*Preliminary Consultation*  
**MONTGOMERY COUNTY HISTORIC PRESERVATION COMMISSION**  
**STAFF REPORT**

<b>Address:</b>	5808 Surrey Street, Chevy Chase	<b>Meeting Date:</b>	7/10/2024
<b>Resource:</b>	Post-1916 (Non-Contributing) Resource <b>Somerset Historic District</b>	<b>Report Date:</b>	7/3/2024
<b>Applicant:</b>	Maya Weil Stephen Santos, Architect	<b>Public Notice:</b>	6/26/2024
<b>Review:</b>	Prelim	<b>Staff:</b>	Dan Bruechert
<b>Proposal:</b>	Accessory Dwelling Unit Construction and Solar Installation

2 RIGHT SIDE ELEVATION  
Scale: 1/4"=1'-0"

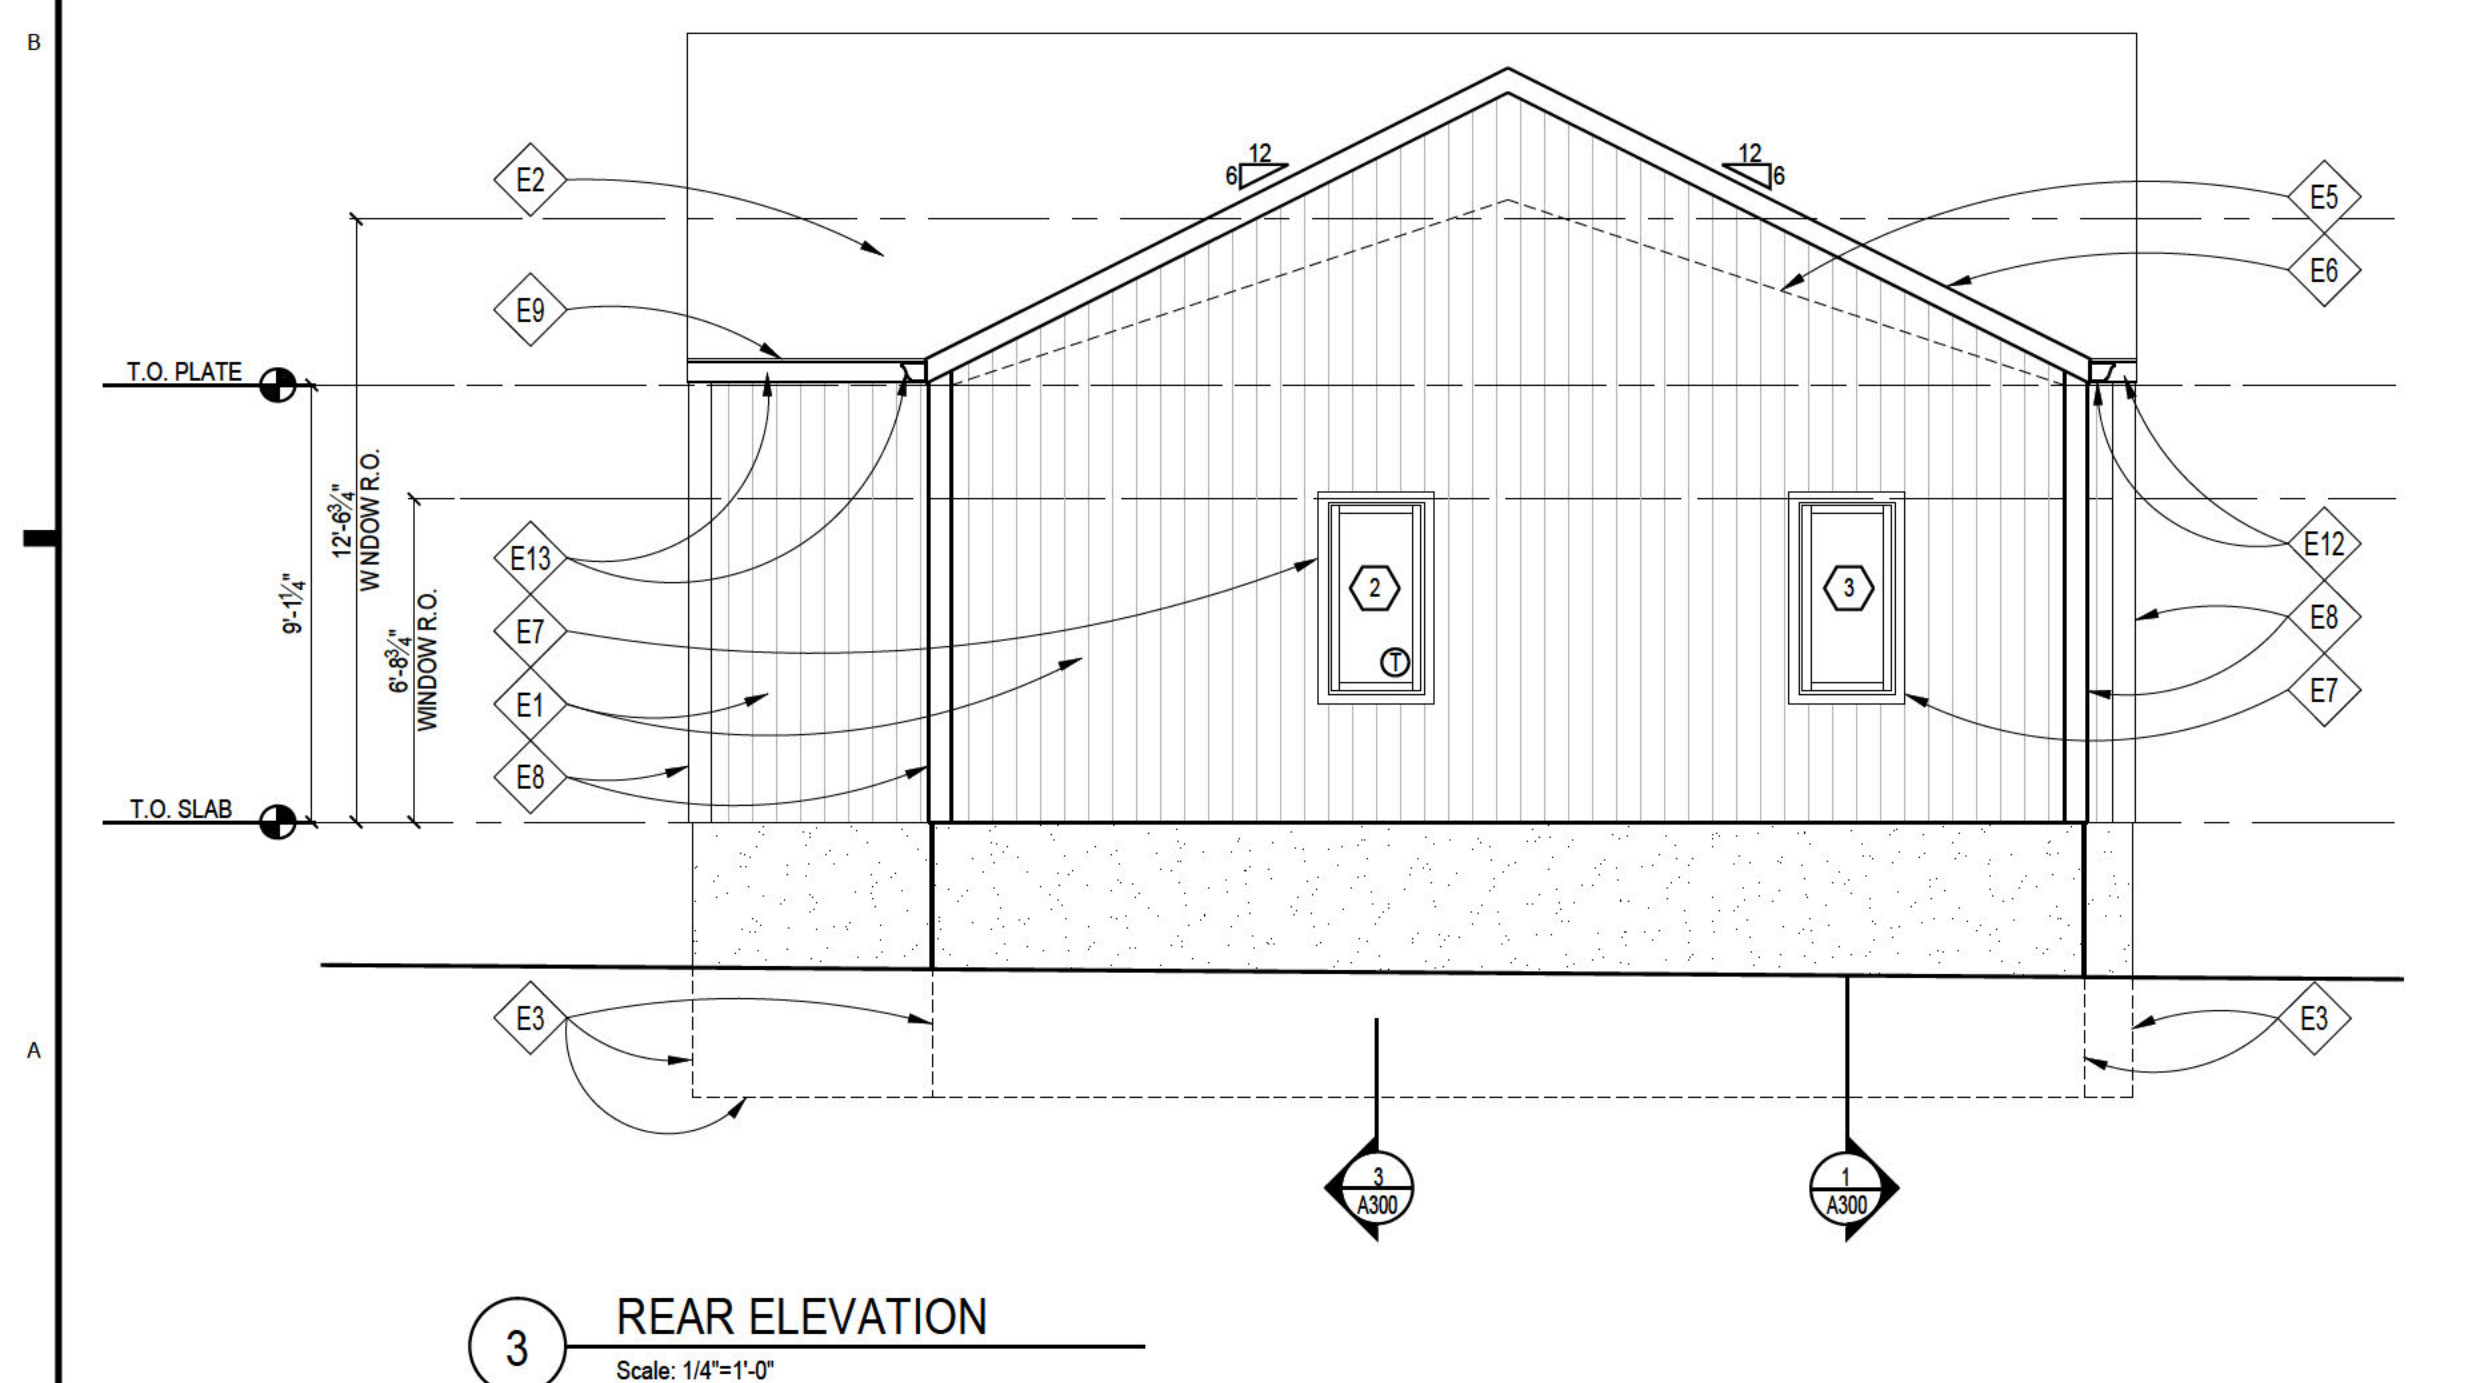
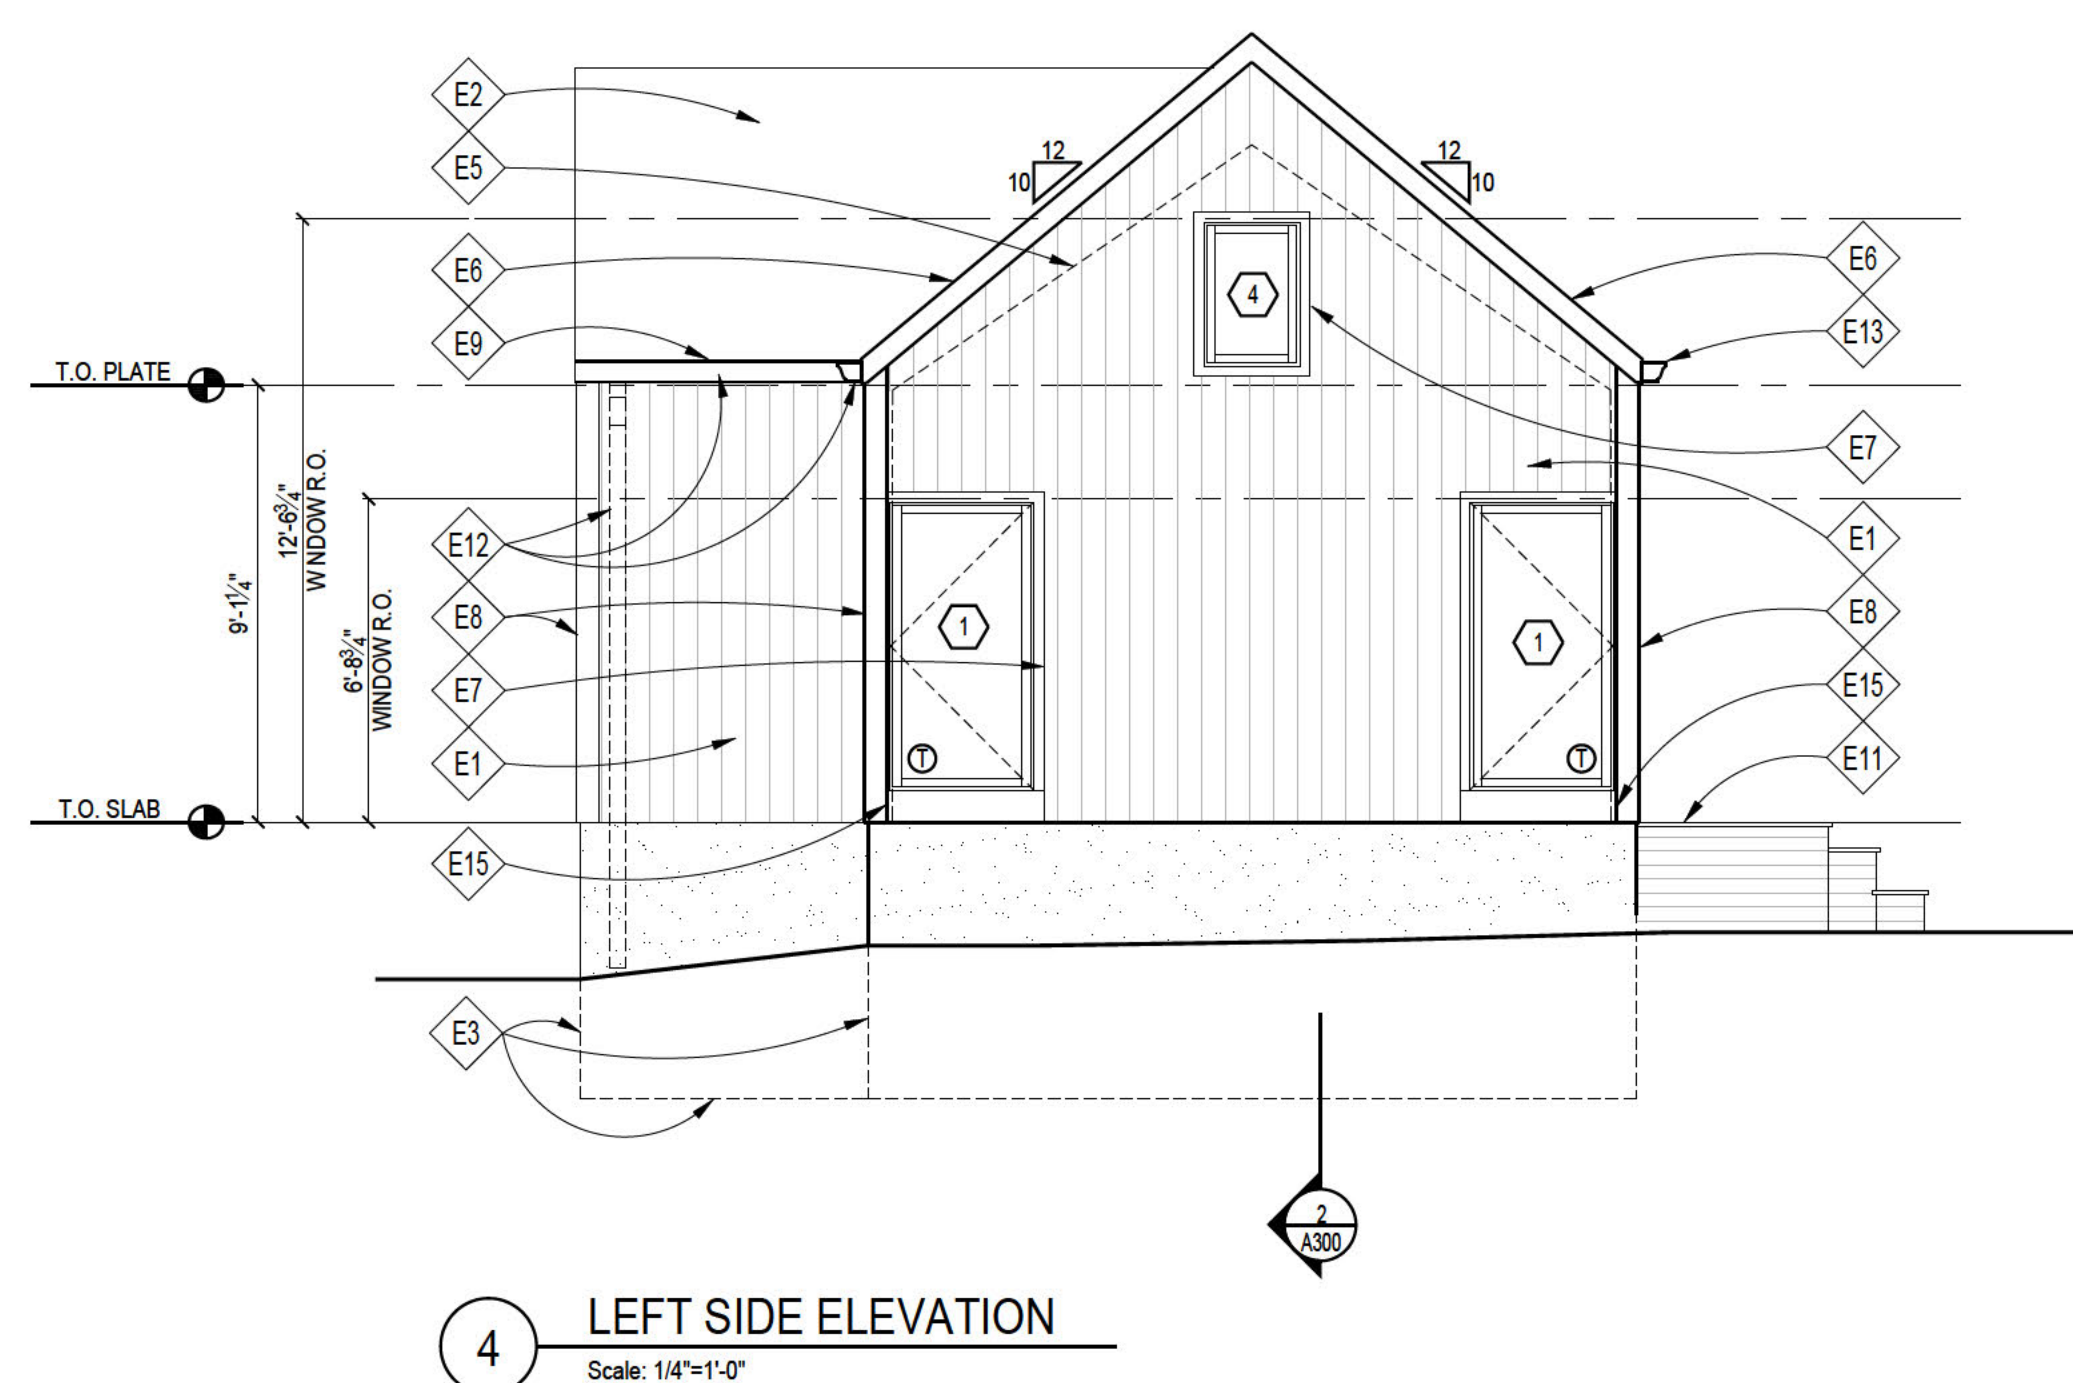
Staff recognizes that substitute materials may be appropriate for additions and new construction within the Somerset Historic District. However, some of the material proposed, such as the Versatex siding, have not been previously reviewed by the HPC. Staff does not have an opinion on this material and recommends the applicant provide a material sample to Staff and the HPC to review prior to (or at) the hearing for this Preliminary Consultation. Staff's preliminary review of the material found that it is paintable and offered in several configurations, but without a visual inspection, Staff cannot recommend the HPC approve the material.

Other materials, like the vinyl windows are not typically approved because they do not adequately replicate the profiles and appearance of a historic wood window. Vinyl windows also are not paintable and do not develop a patina over time. In this instance, the applicant is not attempting to replicate the appearance of a wood window for this contemporary-styled structure. Staff has not found information that indicates the proposed window is paintable, which would obscure its shiny appearance. Additionally, the applicant did not include a section drawing that show the profiles for the proposed window. Staff recommends the HPC require section drawings and more information on the proposed material before the
